TOWN OF MORRISTOWN DEVELOPMENT REVIEW BOARD
WARNED PUBLIC HEARING
COMMUNITY MEETING ROOM OF THE OLD TEGU THEATER
43 Portland Street in Morrisville, VT 05661
6:00 PM Wednesday, September 9, 2026

DEVELOPMENT REVIEW BOARD MEETING MINUTES OF AUGUST 12, 2026

TO: Morrisville DRB
FROM: Holden S. Thompson, EI, B. Dexter Lefavour, PE
SUBJECT: **N.A. Manosh 5 Mountain Minerals Application #2026-59 Response**
DATE: August 7, 2026
CC: Nick Manosh

Sheet No: C-1

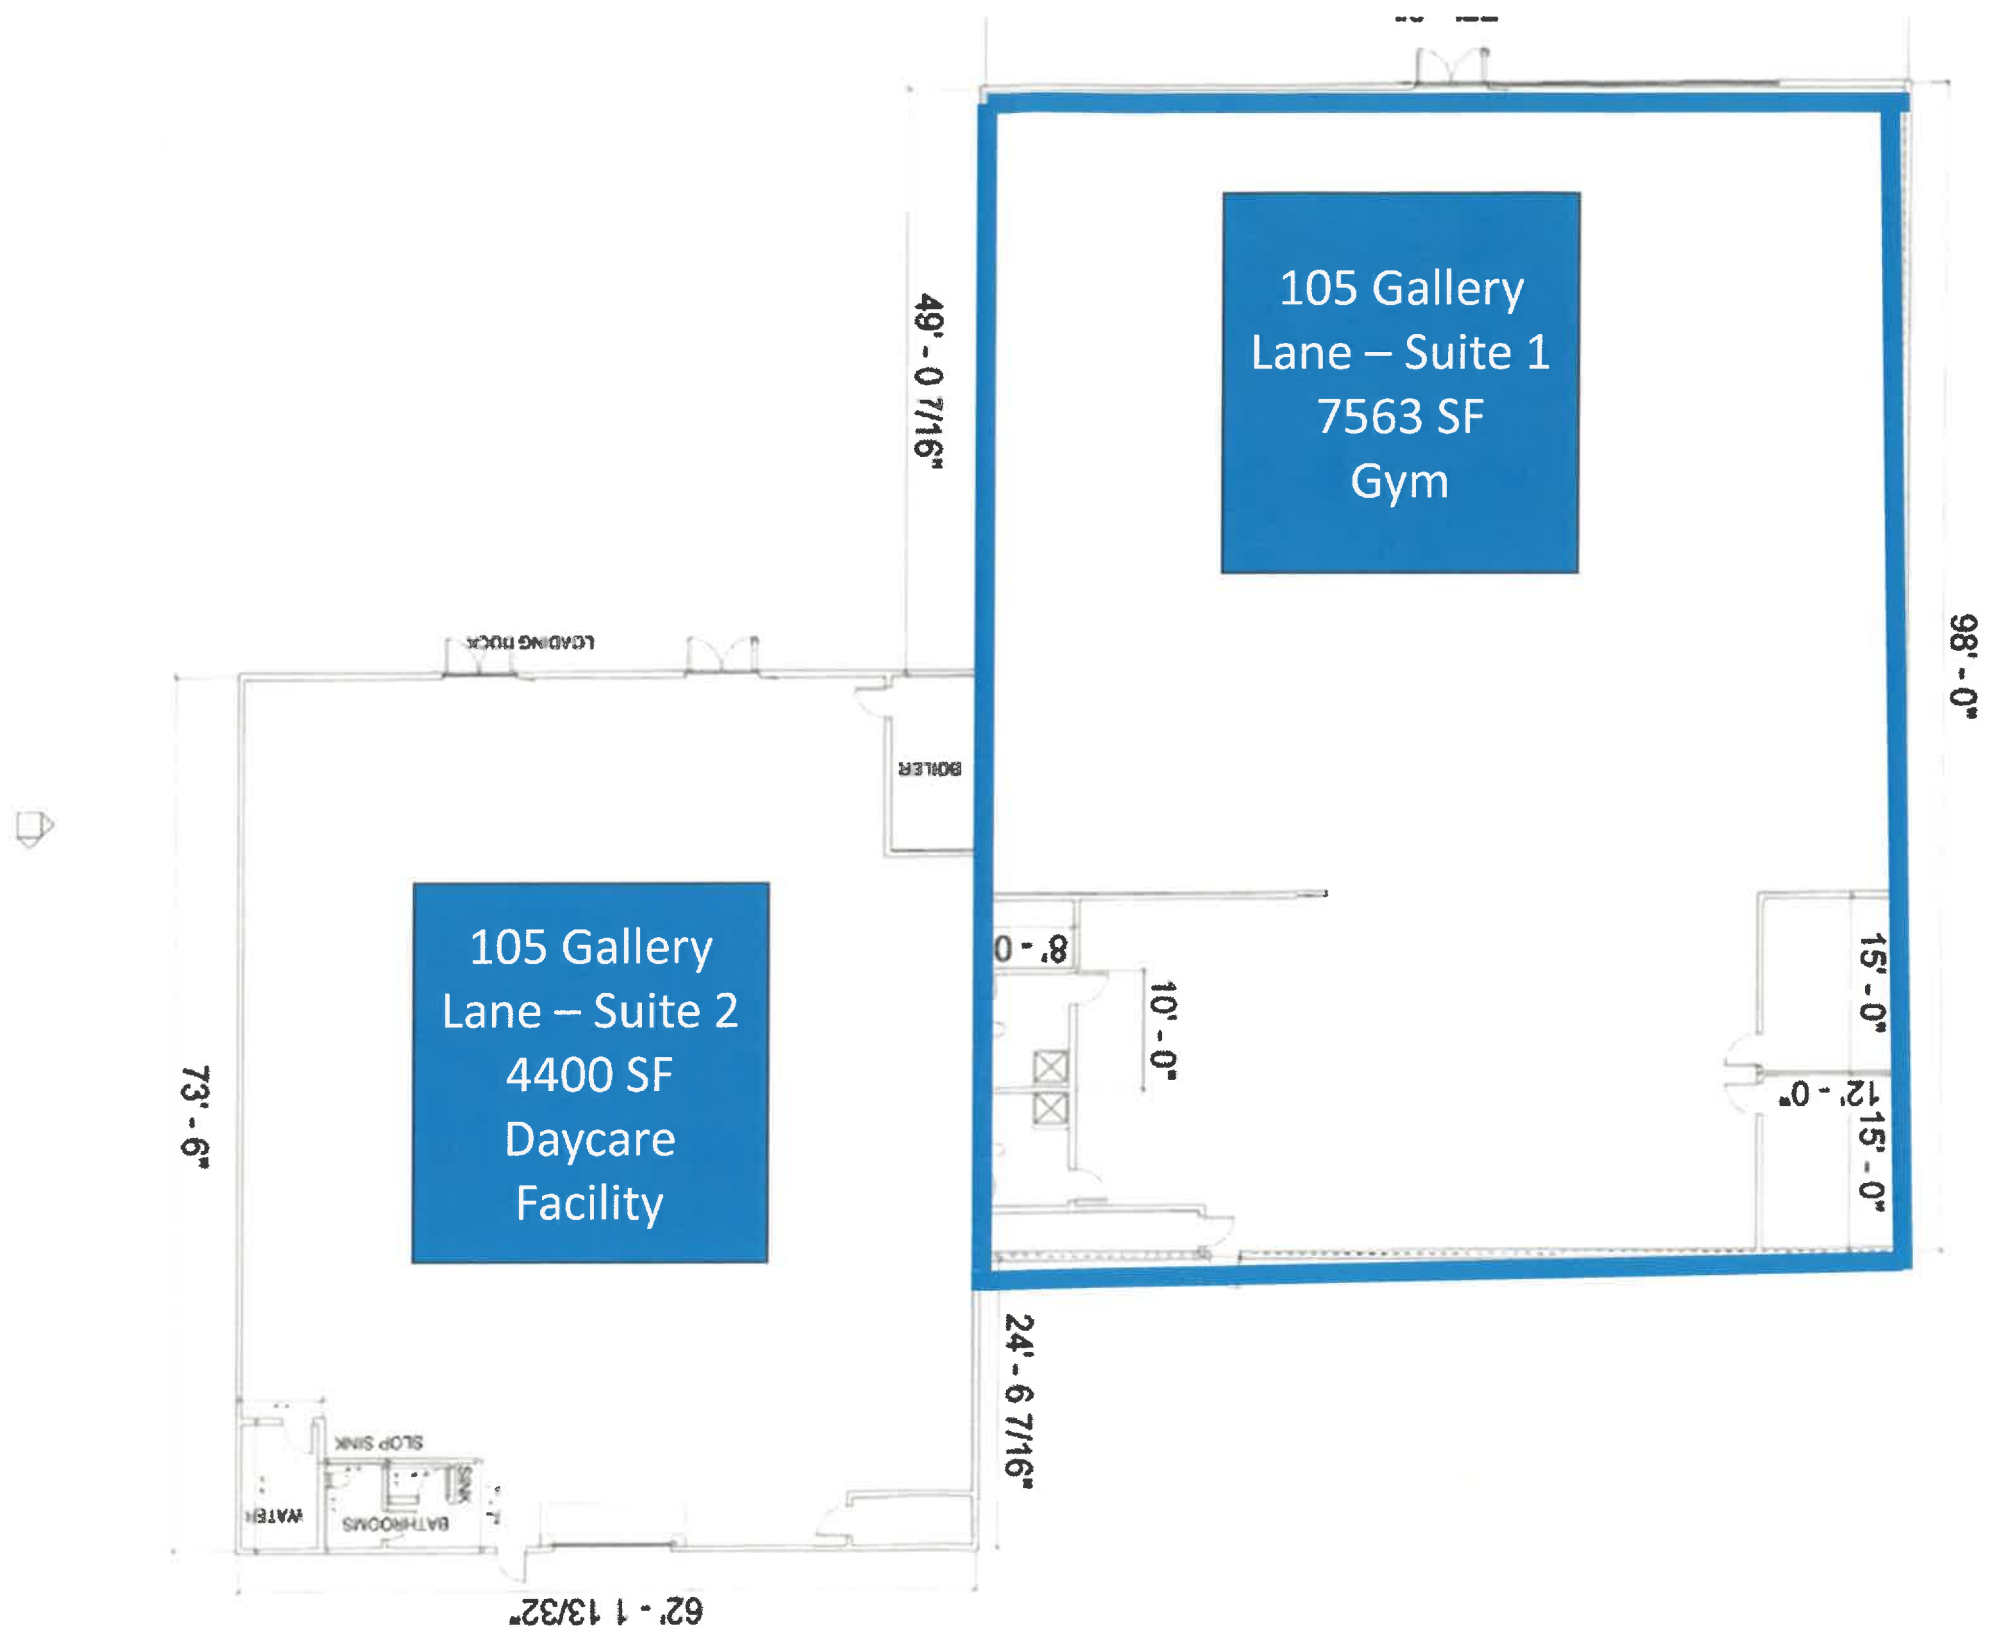
18. The Applicants site plan shows existing landscaping, but no additional landscaping has been provided.

20. The Applicants site plan shows 18 new parking spaces that are located to the rear of the existing buildings. There are no residential lots located near these properties.

C-2

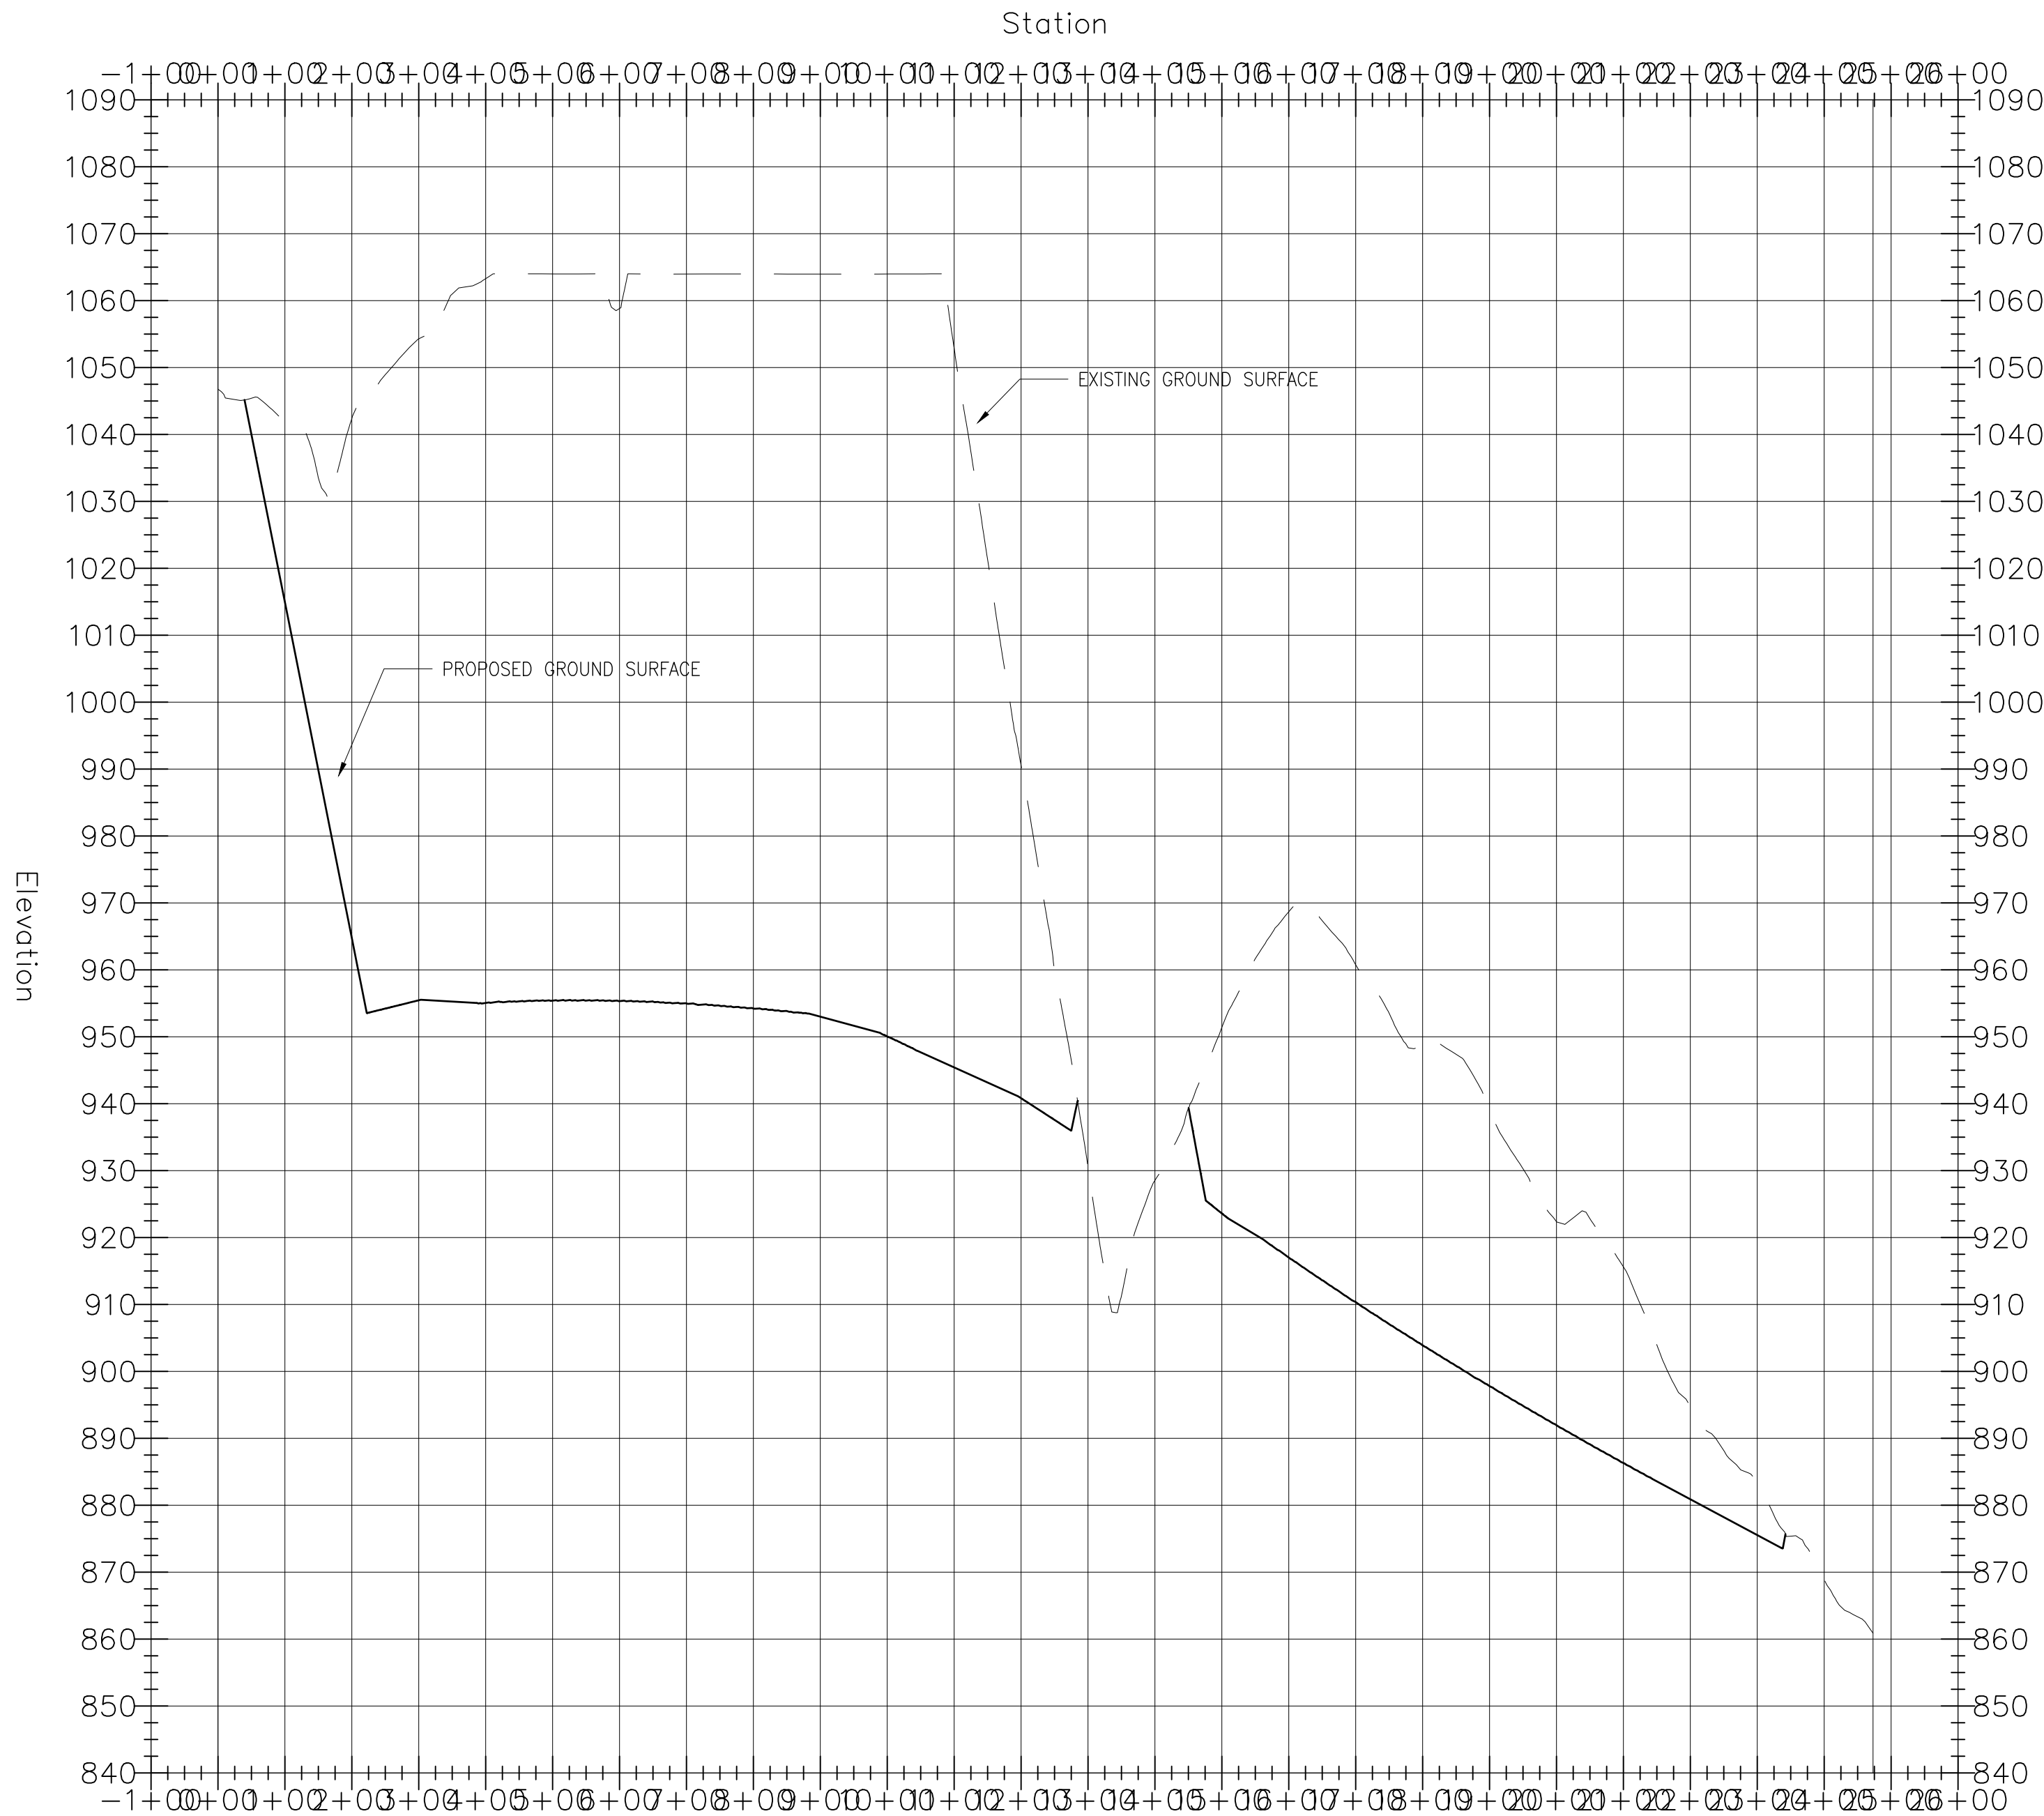
The location of topsoil storage for reclamation will be within the extraction area limits. The removal and storage process is described in the Soil Operations Plan (Section III.c.i). The reclamation process is described in the Soil Operations Plan (Section III.c.ii). A typical location plan for a topsoil storage pile has been added to Sheet C-2. The sequence of operations will generally follow the numbering of sections provided on Sheet C-2.

The applicant will ensure any equipment or machinery on site observes this setback requirement. No sorting machinery or equipment will be operated within 300 feet of any property line as required by Section 485.6. A typical location plan for equipment location on the sites has been added to Sheet C-2.
